UNITED STATES  
NUCLEAR REGULATORY COMMISSION  
WASHINGTON, D.C. 20555-0001

August 22, 2017

SUBJECT: CALLAWAY PLANT, UNIT 1 – NRC RESPONSE TO REQUEST FOR  
EXTENSION OF SEISMIC PROBABILISTIC RISK ASSESSMENT SUBMITTAL

Figure 5-1: Callaway RLG vs GMRS

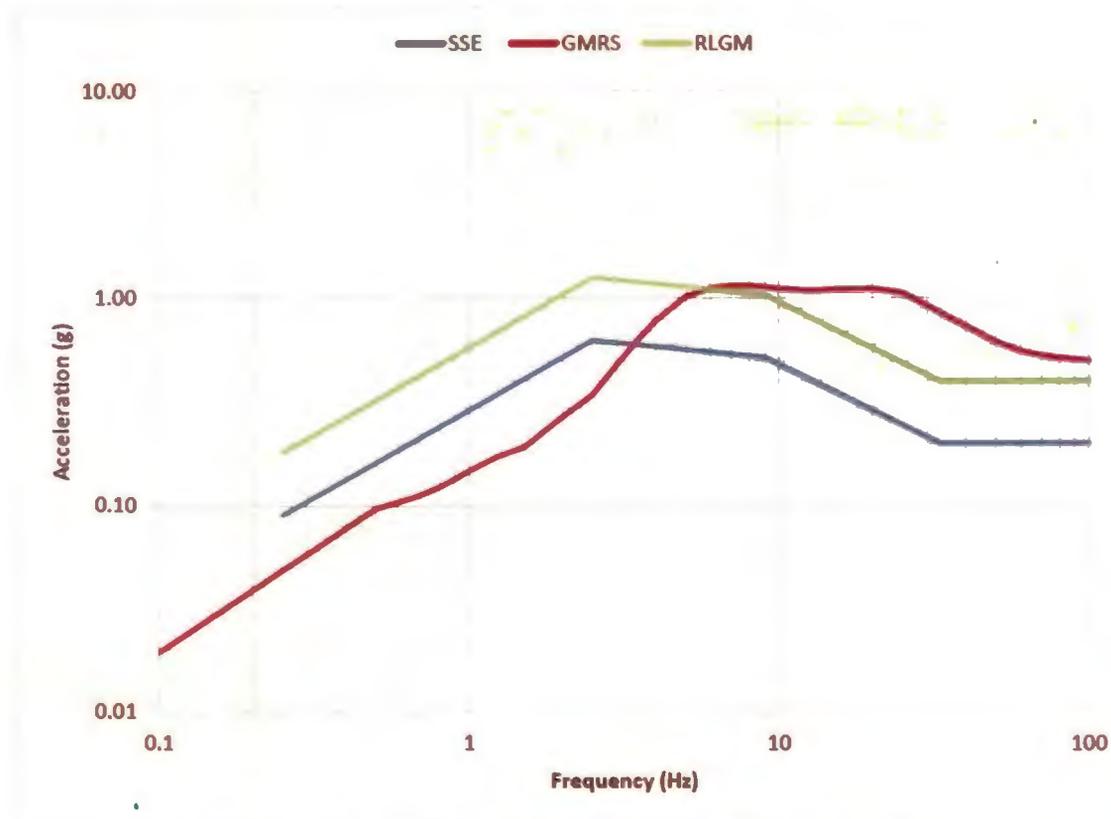
Another significant consideration of the NRC staff was the relationship between the existing design-basis earthquake and the reevaluated seismic hazard at the Callaway site. As documented in the licensee's December 22, 2014, Expedited Seismic Evaluation Process (ESEP) report (ADAMS Accession No. ML14363A311), the maximum ratio of the reevaluated Ground Motion Response Spectrum (GMRS) when compared to the site's design-basis Safe Shutdown Earthquake (SSE) is 2.31. Figure 5-1 from the ESEP report shows a comparison of the Review Level Ground Motion (RLGM) that was used as the seismic hazard for the ESEP

evaluation to the GMRS and the SSE. As described in the following paragraphs, there is inherent seismic margin in the design of nuclear power plants, and Callaway has performed analyses demonstrating that safe shutdown equipment at the plant can cope with an earthquake at least two times the SSE.
